B. PUBLIC AGENDA ITEMS

TO: Planning and Zoning Commission
FROM: Evann Martin, Assistant Planner
DATE: January 4, 2022
RE: Destination Market Plat 7 – Final Plat

RE: Jordison Construction Site Plan

The Development Services Department is in receipt of a proposed Site Plan for Jordison Construction. Based on the review of the provided submittal materials, staff have the following comments:

TOTAL LENGTH OF BUFFERYARD (EAST - MINUS EASEMENT) 362.6 LF

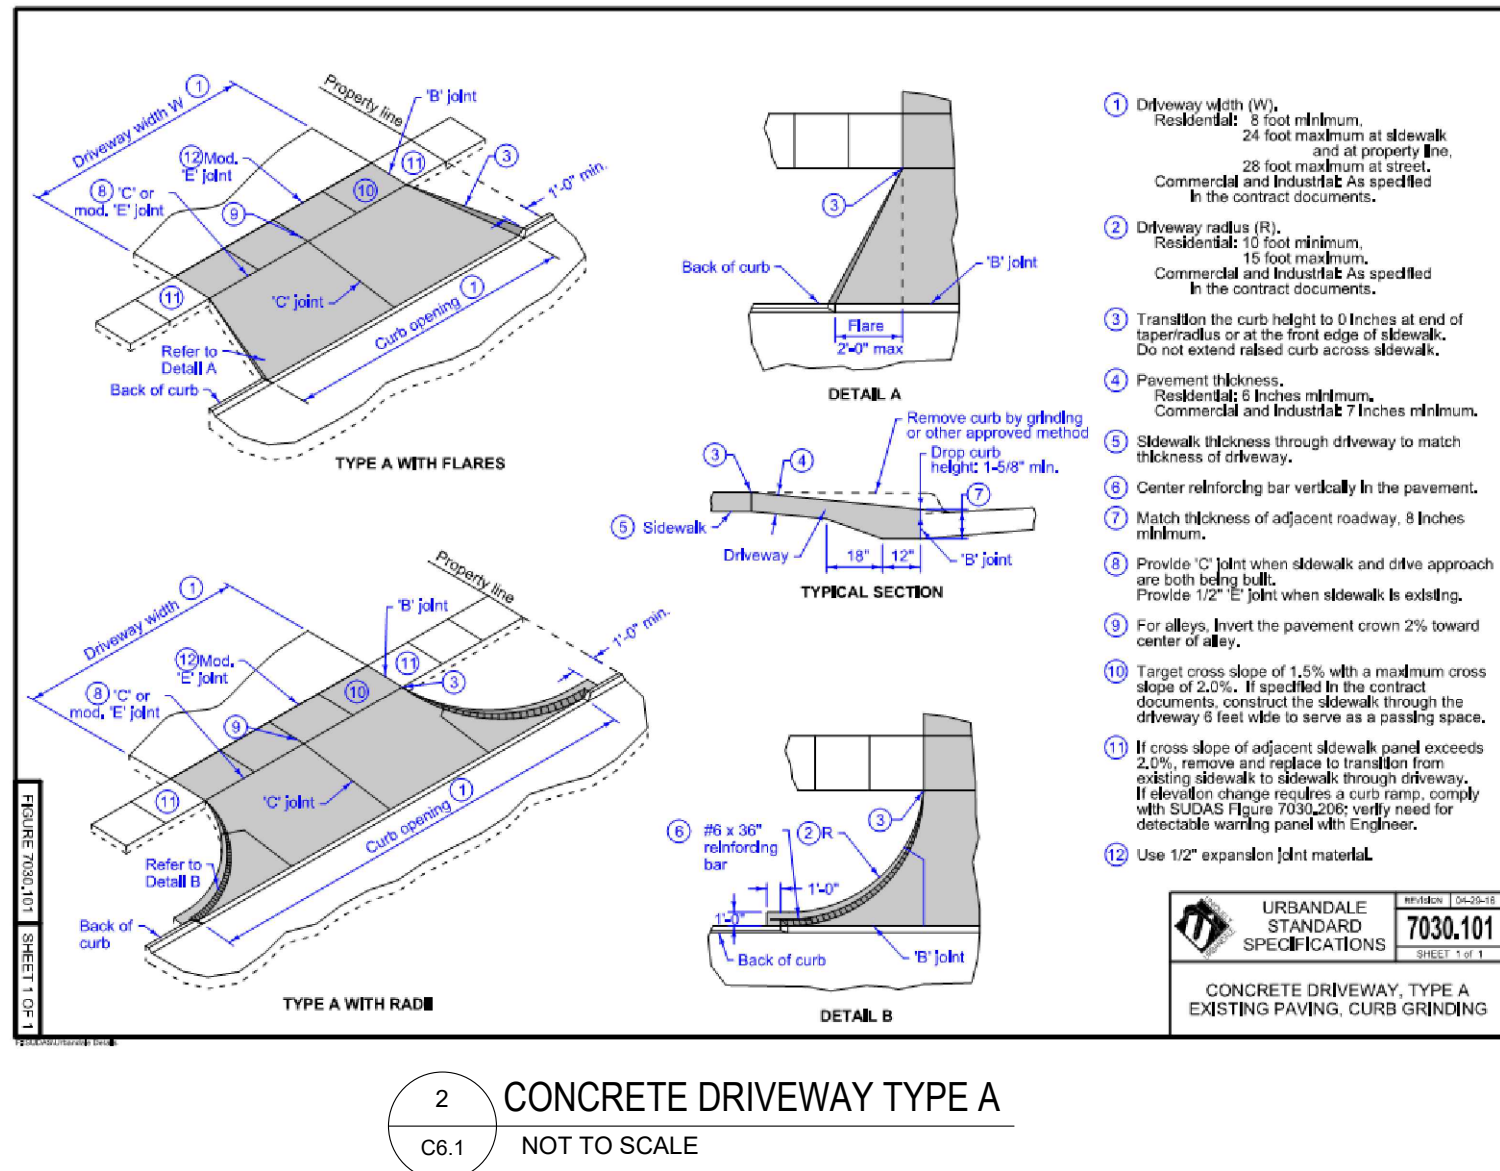
~~1. Structure #6 on the plan is an FES. Please revise label.~~

~~2. On the water service detail, denote that the 2" valve will be on the outside of the building.~~

3. Water service detail to show valve on fire line also.

4. Provide flume detail.

1. Sheet C3.1 or C5.1: Show modified soil area.
2. Sheet C3.1: Any erosion control or energy dissipation needed at the curb cuts?
3. Sheet C6.1, Detail 8: Show mulch layer as a minimum of 3".

A-202

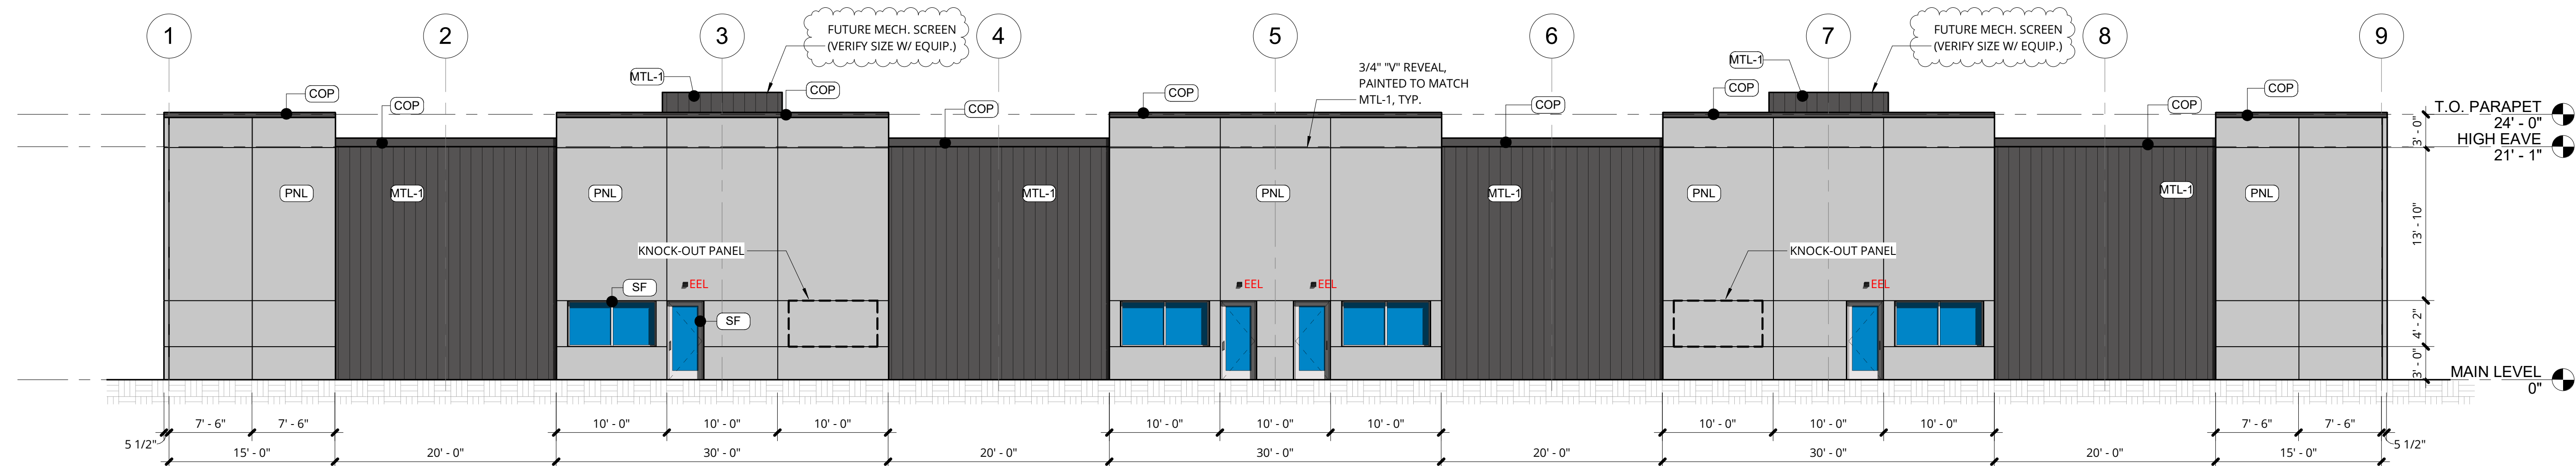
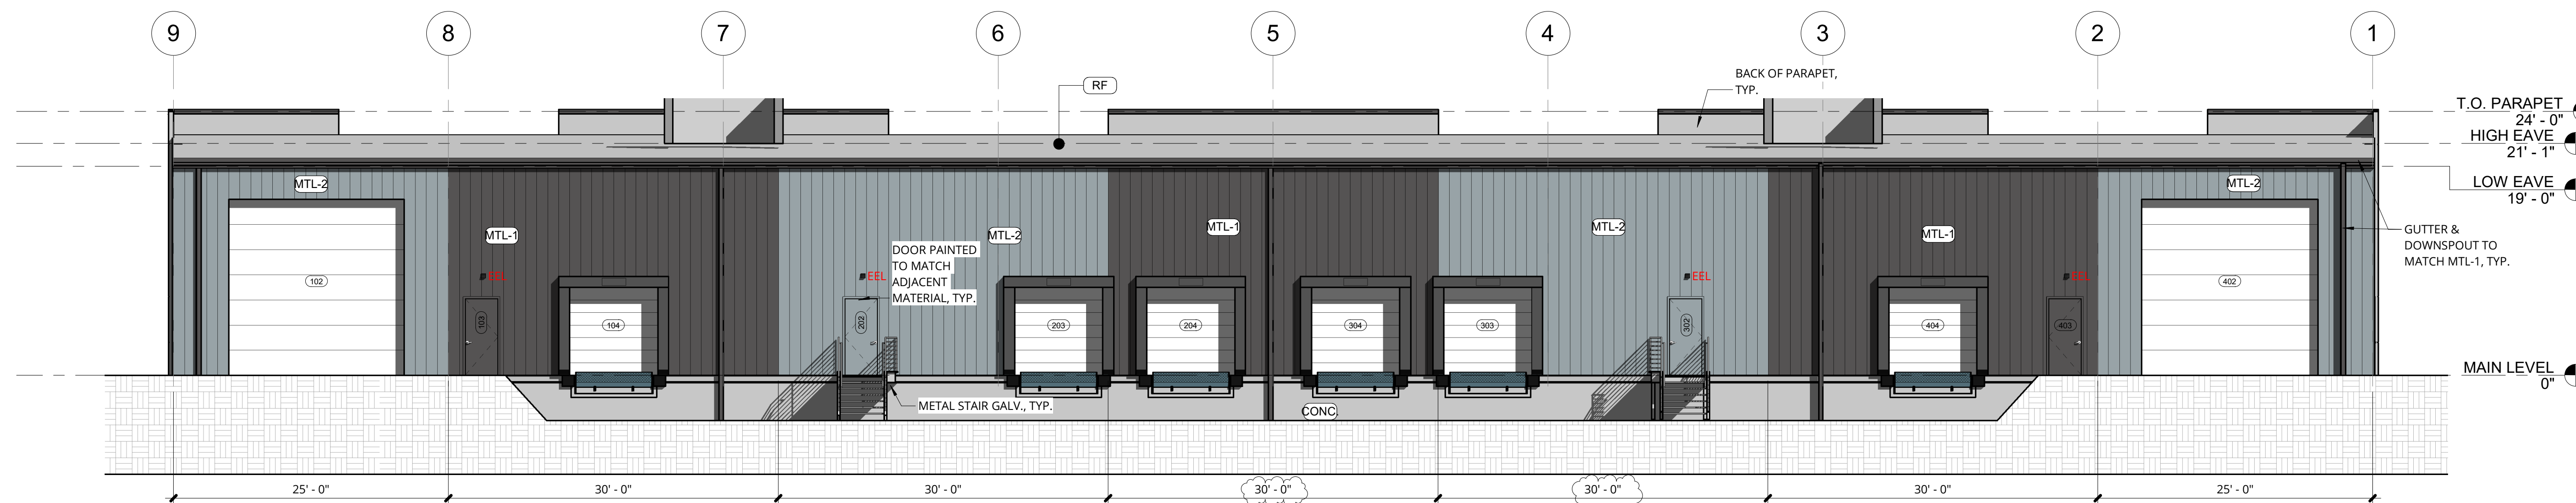
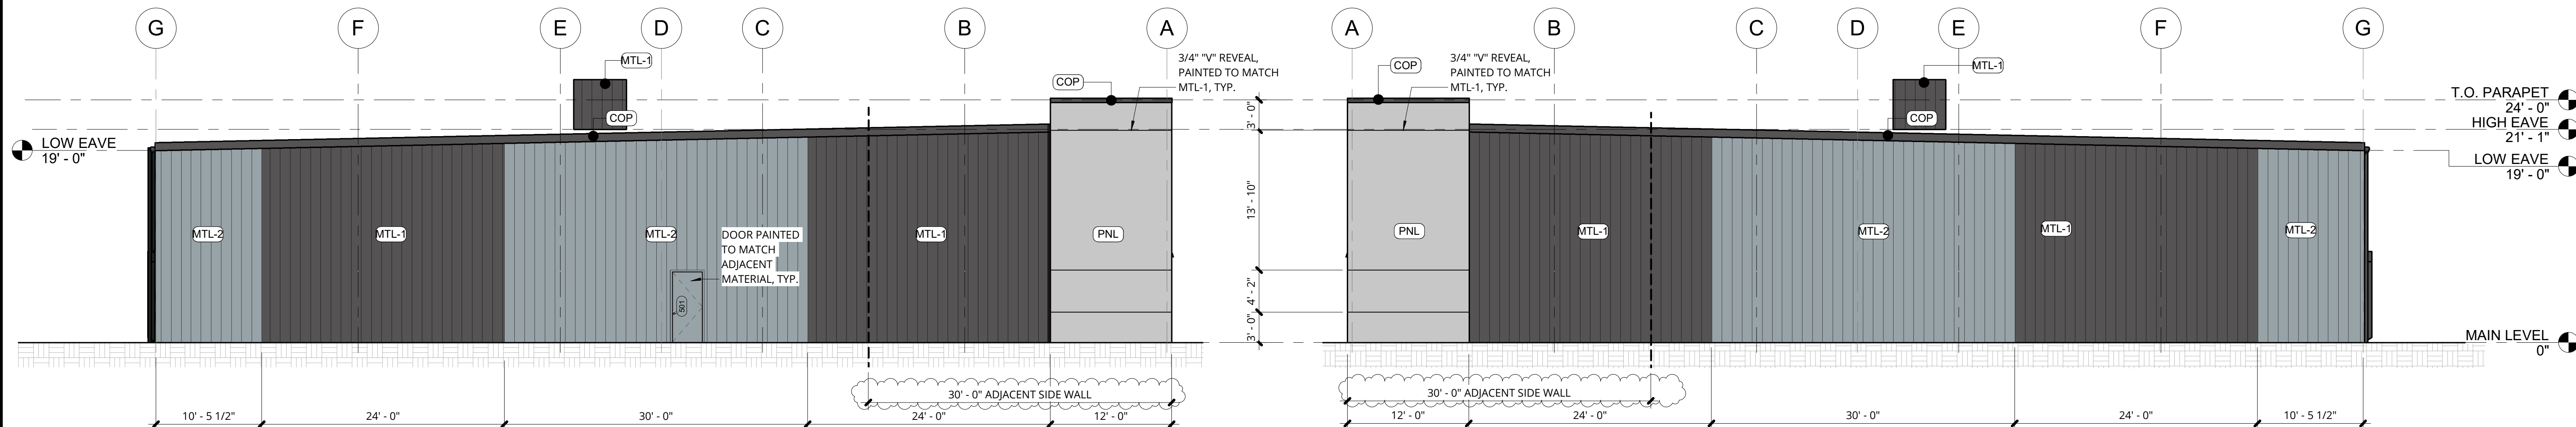
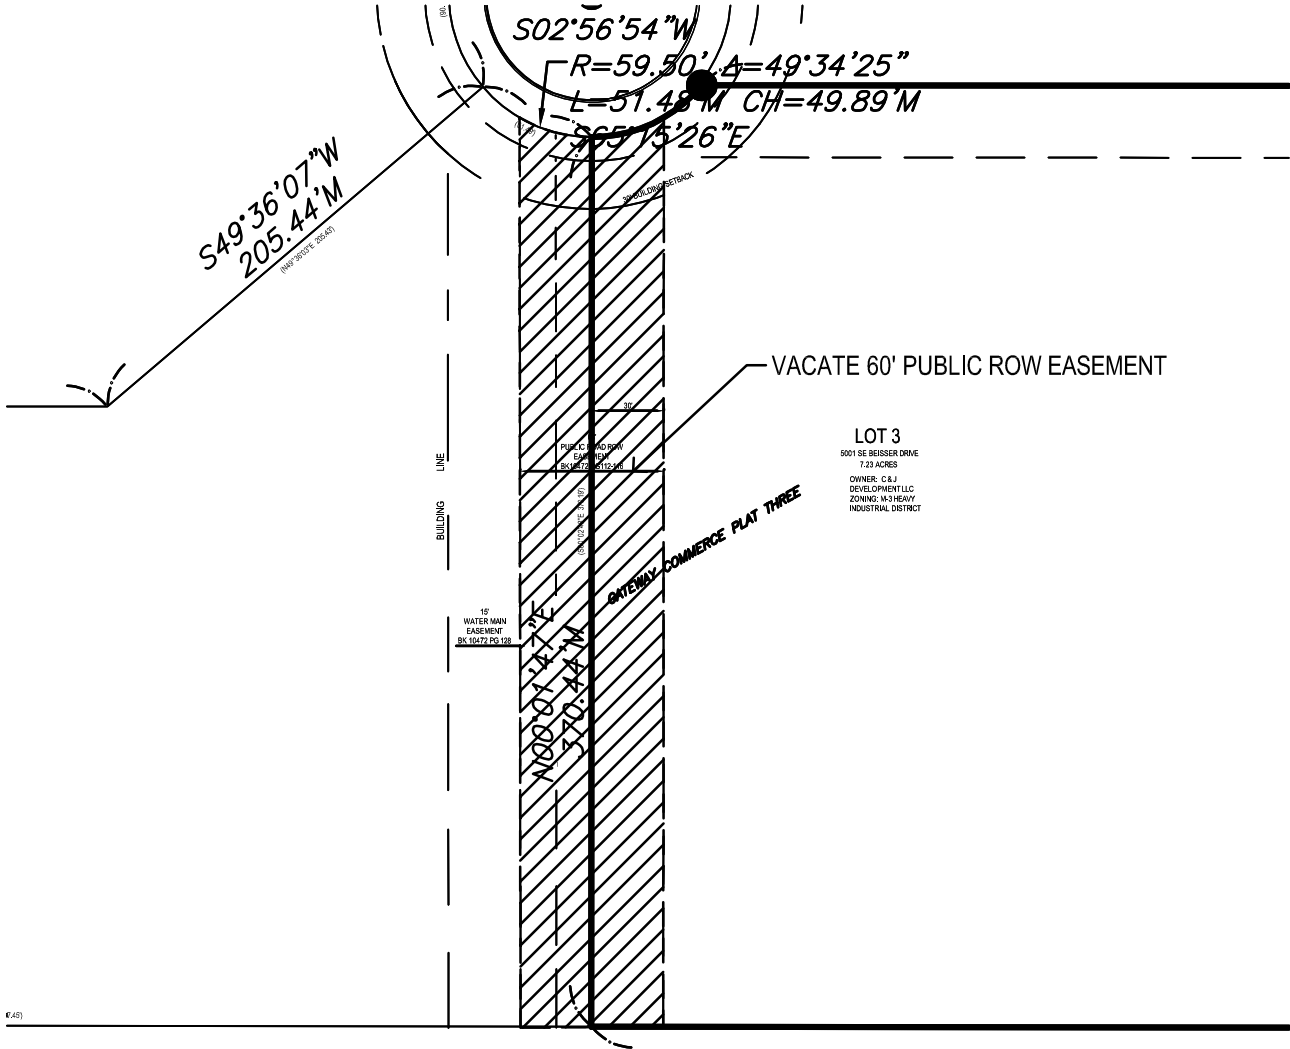
11. ~~On the building elevation, a door is shown on the east elevation. On the site plan, there is no sidewalk or landing for the proposed exit to a parking lot or a public way. Per section 1028.5 of the 2018 International Building Code, a direct and unobstructed access to a public way is required. Please provide a sidewalk and landing for the door on each building.~~

- ~~1. Are all three buildings proposed to be identical?~~
- ~~2. Provide building lighting cut sheets and label locations.~~
- ~~3. Roof mounted equipment shall be screened by the parapet walls. If the parapet walls cannot provide adequate screening, provide point in place screening and provide a detail for the screen.~~
- ~~4. Provide building material percentages. Facades facing the public street and a minimum of 30' on the adjacent side wall shall be at least 25% masonry.~~
5. Label an exterior emergency light on the east emergency exit.
6. Where are the floodlights proposed to be placed on site?
7. Provide dumpster enclosure and gate details.
